**Planning, Development
and Transportation**

DATE: 04.07.2016
TO: ProTrak
FROM: Bill McDow
Transportation Planning

■ **RENAISSANCE II BUILDING [TRC Plan Review #2]**

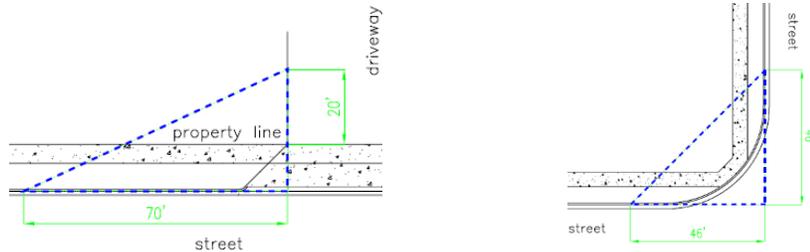
1. The right turn lane for Fresco Drive does not appear to have adequate taper and storage.
2. Show any traffic signal facilities and equipment in front of the development. Contact Traffic Engineering at 341-7888 for help in identifying these.
